MS-3110
C

REQ'D.	ITEM	PART NUMBER	DESCRIPTION	SYMBOL
F. BUDETTI LIST OF MATERIAL				
MATERIAL 6061 ALUMINUM 5052-H32			THE TECHNICAL MATERIEL CORP. MAMARONECK, NEW YORK	
FINISH S404-YELLOW IRIDITE S114-ZINC CHROMATE PRIMER S115-SMOOTH GRAY ENAMEL			TITLE MOLDING, CORNER	
UNLESS OTHERWISE SPECIFIED DIMENSIONS ARE IN INCHES AND INCLUDE CHEMICALLY APPLIED OR PLATED FINISHES				
DRAWN GDL		DATE 3-16-63	FINAL APPROVAL [Signature]	
CHECKED aa		DATE	MS-3110	
ELECT. DES. [Signature]		DATE	C	
MECH. DES. [Signature]		DATE	REV. LTR.

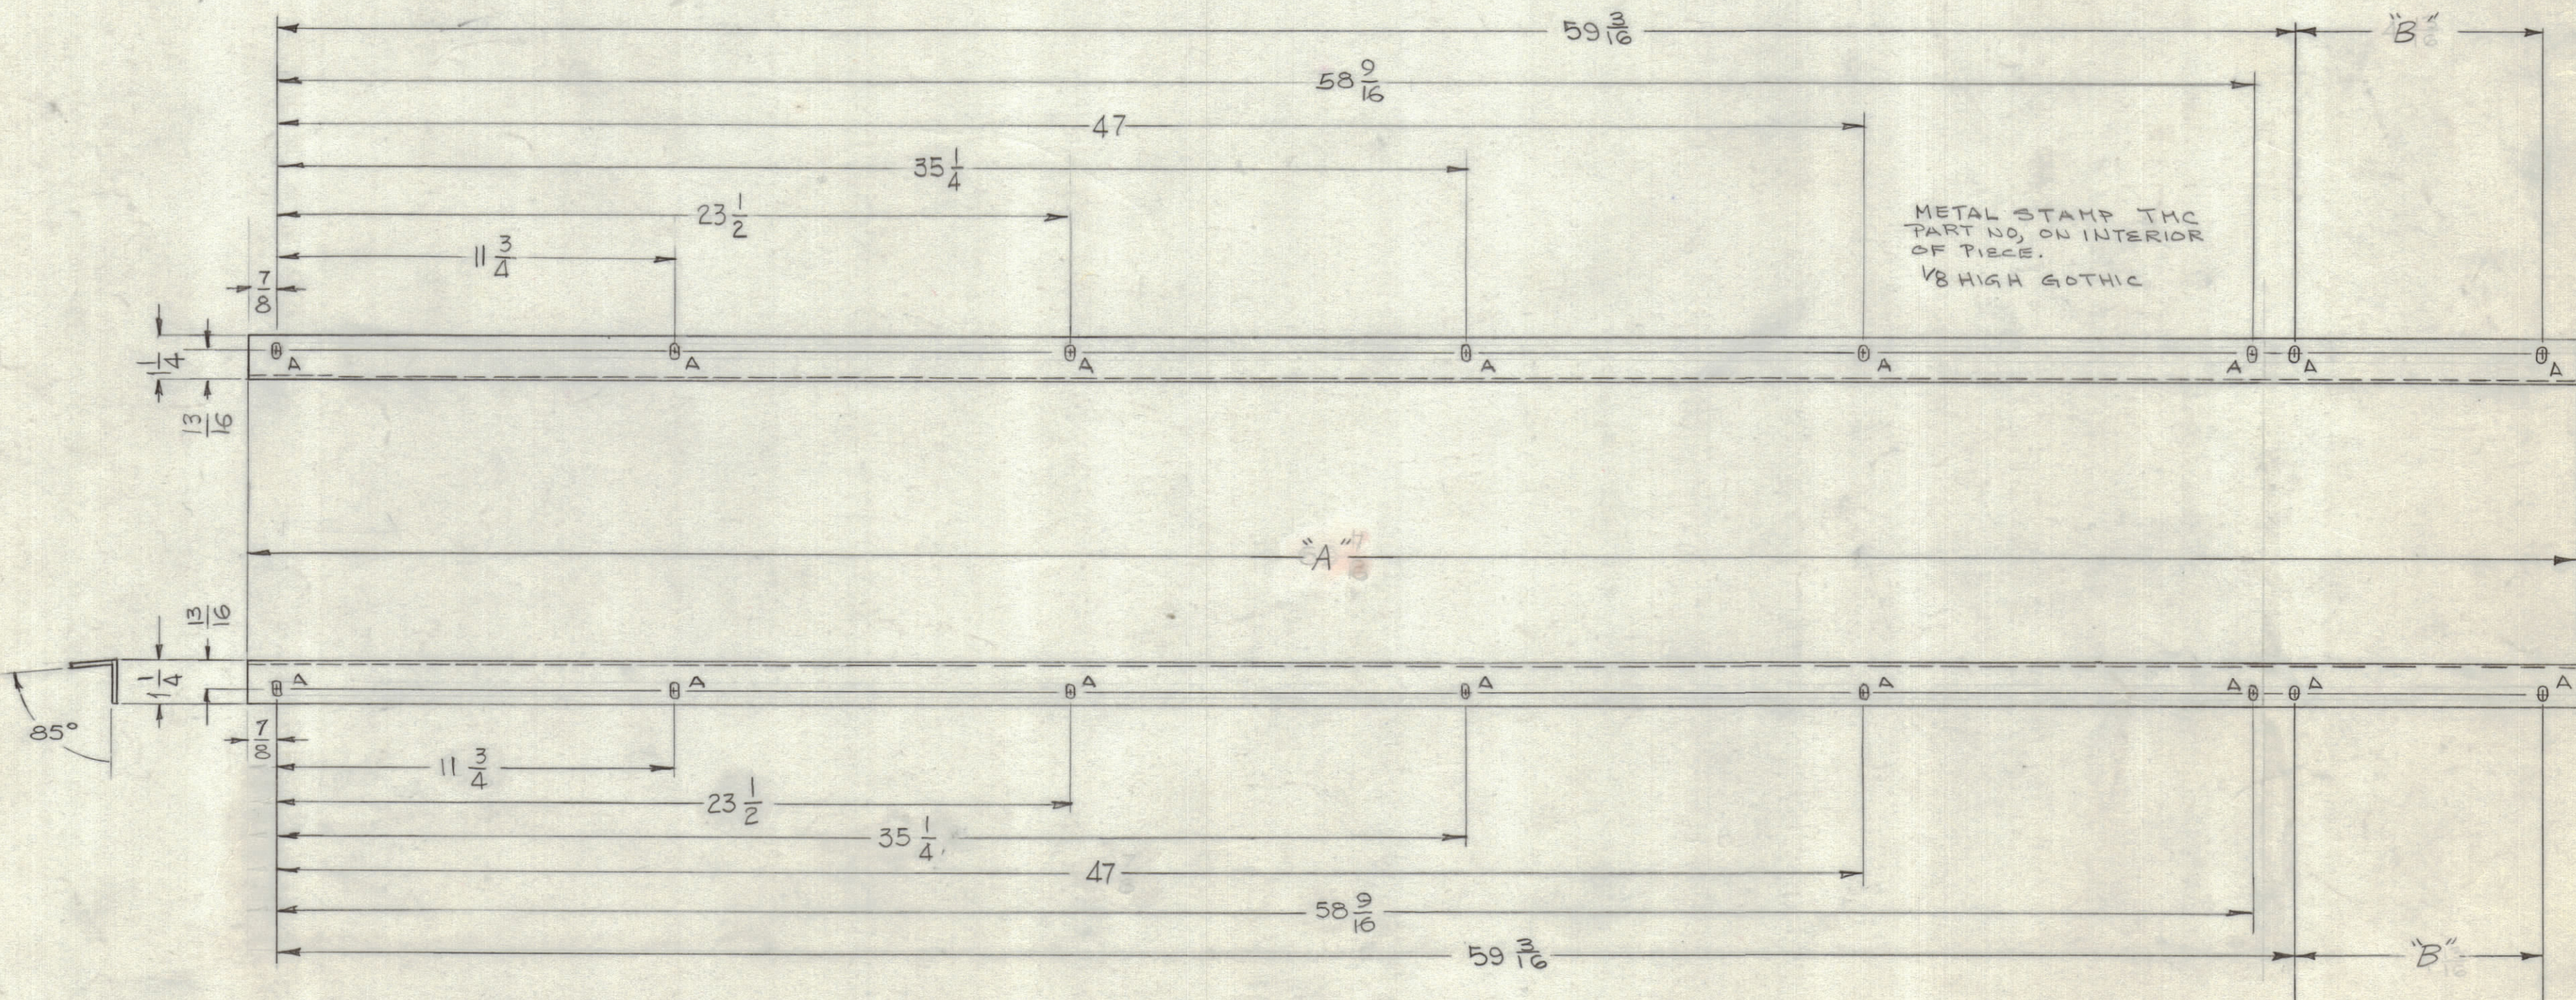
REVISIONS						
ZONE	SYM	DESCRIPTION	DATE	E.M.N. NO.	DRAFT	CHKD
F3, E1	A	LENGTH OF PIECE WAS 59 3/16, ADDED 4 'A' SLOTS AT DIMS 59 3/16 & 4 1/16	4-28-63	8832		
H7	B	IN HOLE LEGEND, DESCRIPTION WAS 1/16 X 11/32 SLOT	7/23/63	10,025		
	C	DIM A WAS 67-7/8, DIM B WAS 4-13/16 TMC PART NUMBER CHART ADDED	9/11/65	14540
